W3F1-2017-0067

Subject: License Amendment Request to Remove Technical Specification 3/4.3.2
Table 4.3-2 Note 3 Exemption for Testing Relays K114, K305, and K313
Waterford Steam Electric Station, Unit 3 (Waterford 3)
Docket No. 50-382
License No. NPF-38

Analysis of Proposed Technical Specification Change

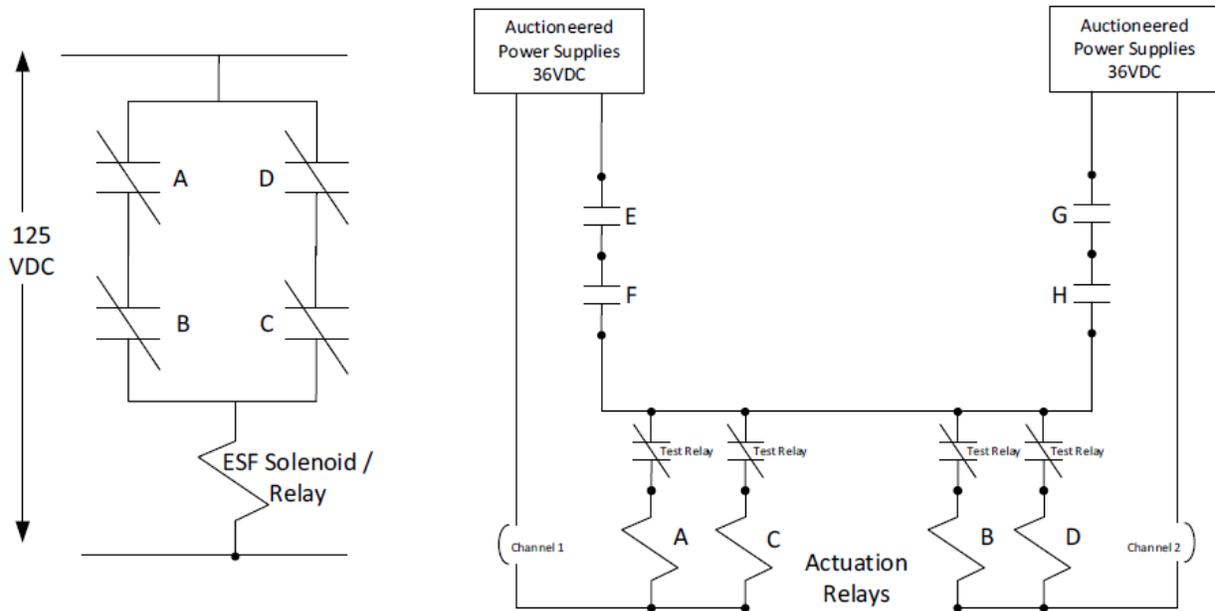
The following figure shows the simplified current configuration of the ESFAS single point vulnerability. This is a generic arrangement for explanation purposes. The specific relay changes will be shown in the next sections.

The ESFAS single point vulnerability is associated with the power supply arrangement. If a short circuit were to occur across the relay A coil, power would be lost to the left half of the ESF bus resulting in the de-energization of relays A and C. Such failures would not affect relays B and D as these have a separate negative and circuit breaker. Under this scenario, the ESF equipment associated with relay A would actuate. This is the single point vulnerability identified for MSIS relays K305 and K313, and for CSAS relay K114.

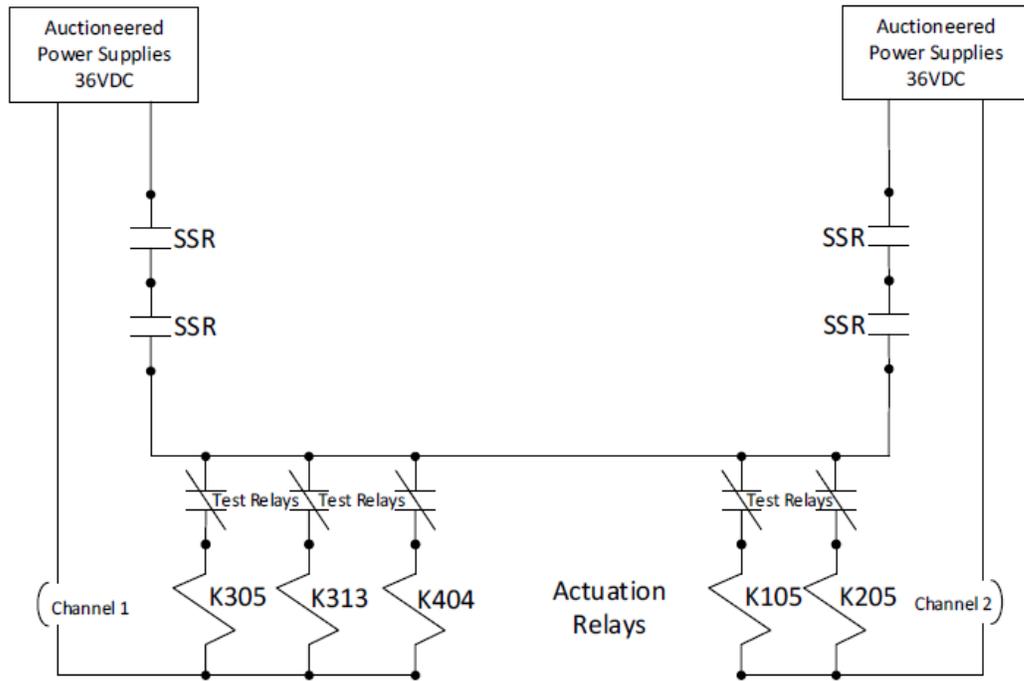
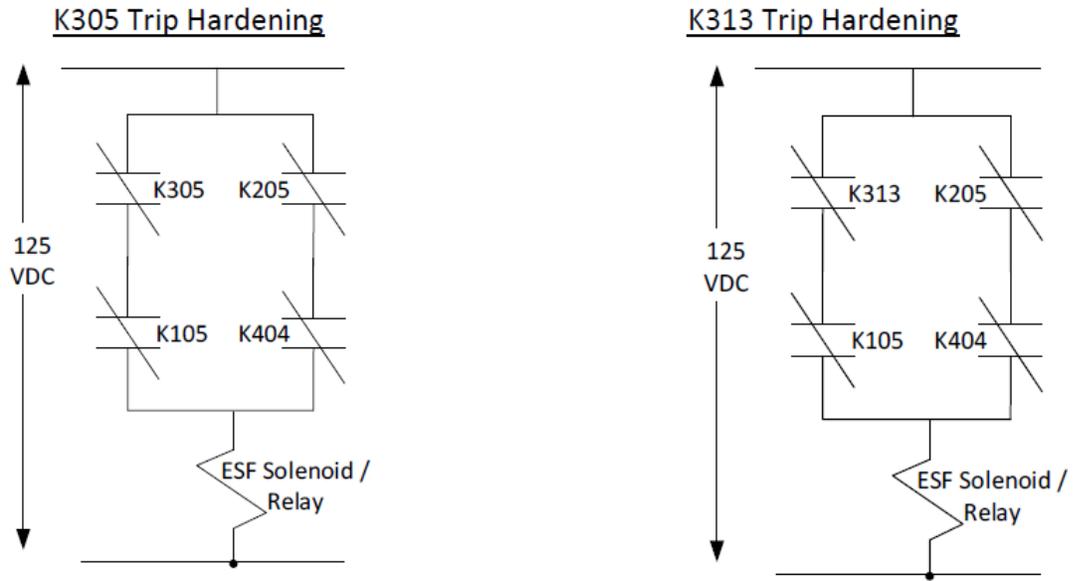
The K305 relays will be trip hardened by adding 3 additional relays creating a 2 out of 2 paralleled with 2 out of 2 logic scheme. Spare relays used to trip harden the K305 relay are K105, K205, and K404. K305 and K404 are powered from one power supply while K105 and K205 are powered by a separate power supply. K305 trip hardened contacts are wired in series with K105 contacts. K205 contacts are wired in series with K404 contacts. K305 AND K105 OR K205 AND K404 are required to close to actuate associated downstream ESF equipment.

The K313 relays will be trip hardened by adding 3 additional relays creating a 2 out of 2 paralleled with 2 out of 2 logic scheme. Spare relays used to trip harden the K313 relay are K105, K205, and K404. K313 and K404 are powered from one power supply while K105 and K205 are powered by a separate power supply. K313 trip hardened contacts are wired in series with K105 contacts. K205 contacts are wired in series with K404 contacts. K313 AND K105 OR K205 AND K404 are required to close to actuate associated downstream ESF equipment.

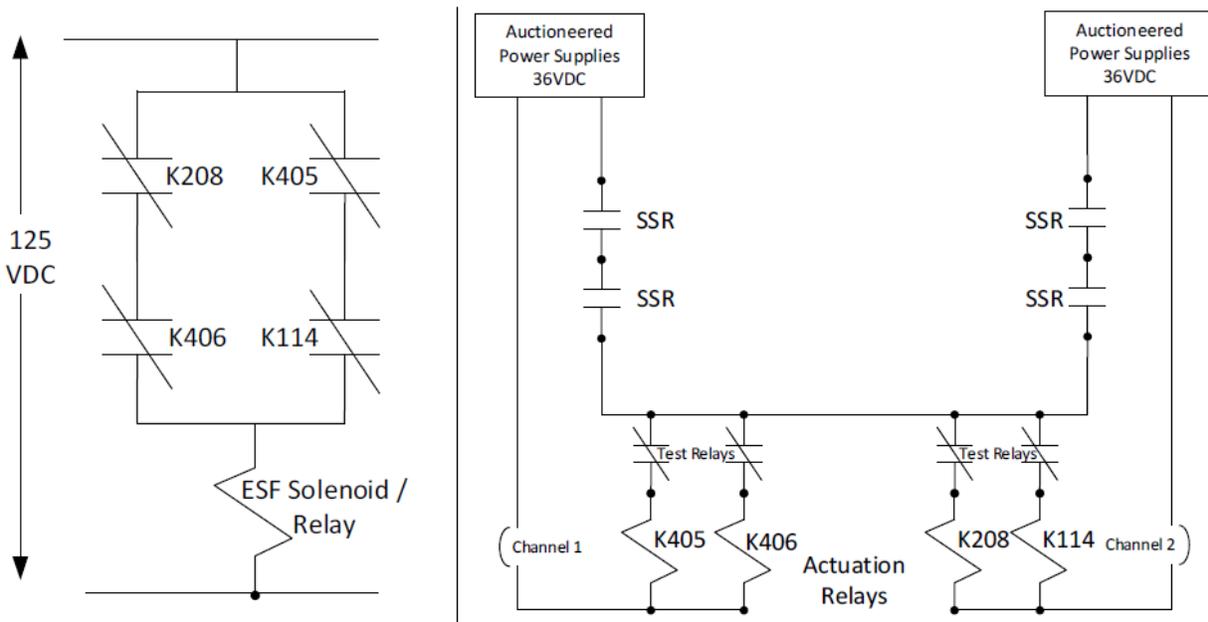
The K114 relay will be trip hardened by adding 3 additional relays creating a 2 out of 2 paralleled with 2 out of 2 logic scheme. Spare relays used to trip harden the K114 relay are K208, K405, and K406. K114 and K208 are powered from one power supply while K405 and K406 are powered by a separate power supply. K114 trip hardened contacts are wired in series with K405 contacts. K208 contacts are wired in series with K406 contacts. K114 AND K405 OR K208 AND K406 are required to close to actuate associated downstream ESF equipment.

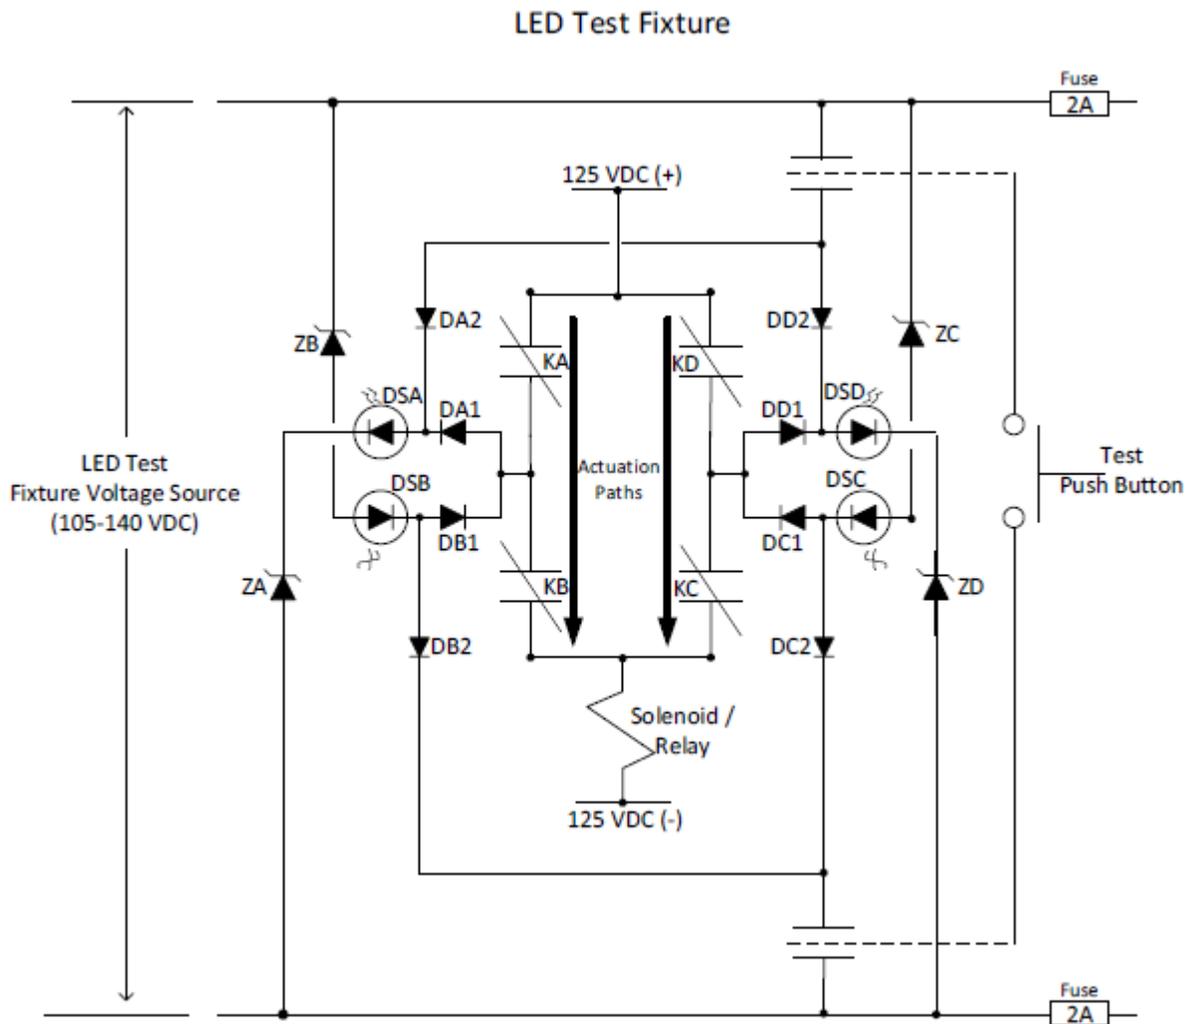
The next figure is a simplified diagram of the LED Test Fixture. KA through KD are the subgroup actuation relay contacts. DSA through DSD are the LEDs used to monitor their respective actuation contact. The following examples assume all contacts are open unless stated otherwise. As an example, assume Operations is performing an online surveillance test of each relay (KA, KB, KC, KD) discretely, meaning only one is being tested at a time. The first step Operations will perform is verifying the LEDs are working properly by depressing the 'Test Push Button.' Once all LEDs are verified illuminated, the pushbutton will be released, extinguishing the LEDs. Next, Operations will verify no LEDs remain illuminated (which would indicate a failed actuation relay or contact). Once all LEDs are verified extinguished, testing may be performed. Assume KA is under test. Contact KA is monitored by LED DSA. When KA is closed, DSA is illuminated (ON). When KA is open, DSA is not illuminated (OFF). The remaining LEDs (DSB through DSD) function in the same manner.
